# EQUIPMENT UPDATE

**Log Number:** EU-9-378

**Part:** CONVEYOR CLUTCH SPRING

**Models Affected:** CMA-44/CMA-66 CONVEYORS

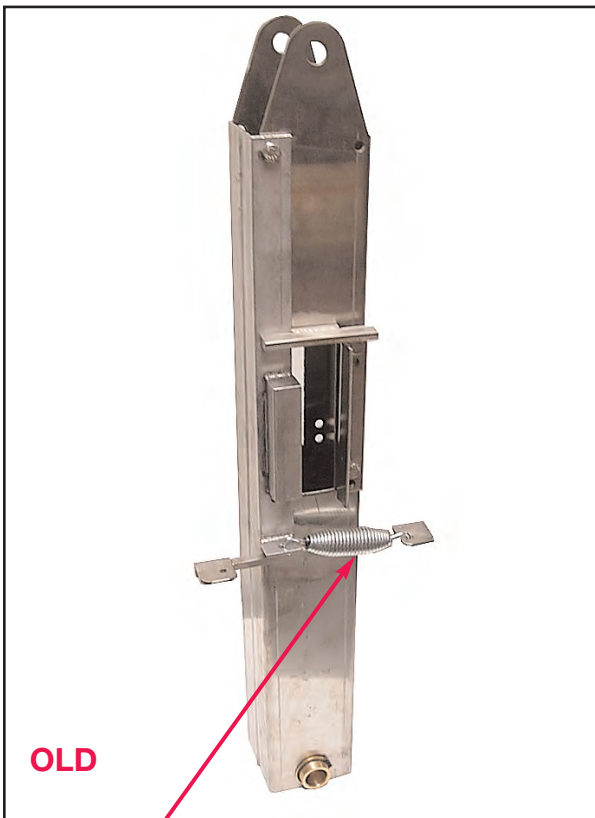
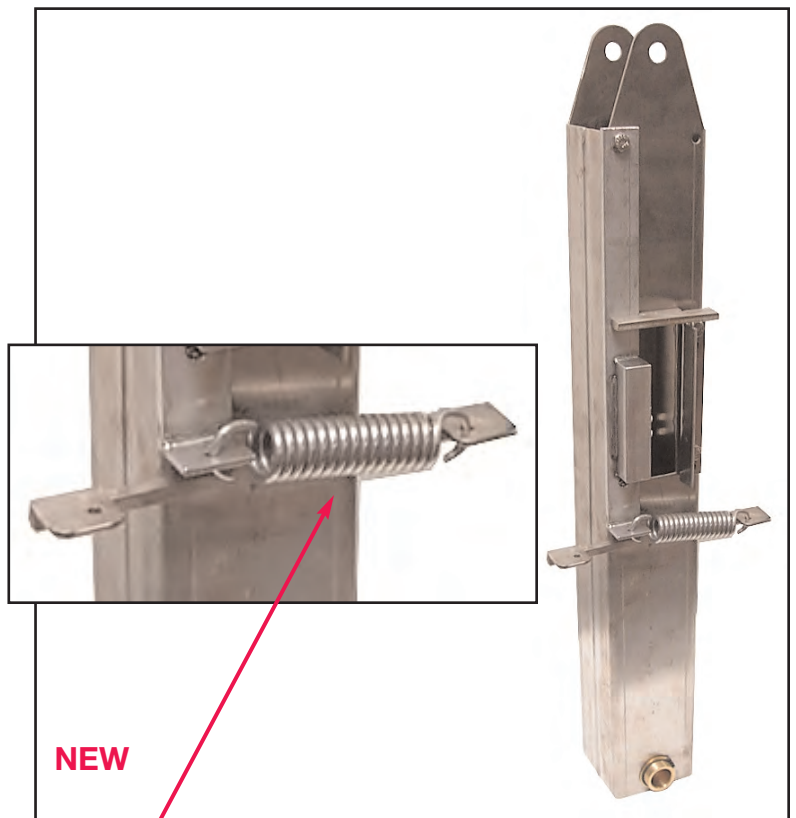
Present Conveyor Clutch Spring has a tendency to break under heavy load and use.

The NEW Conveyor Clutch Spring has been strengthened and improved to prevent premature breakage. The coil gauge and tensile is considerably stronger.
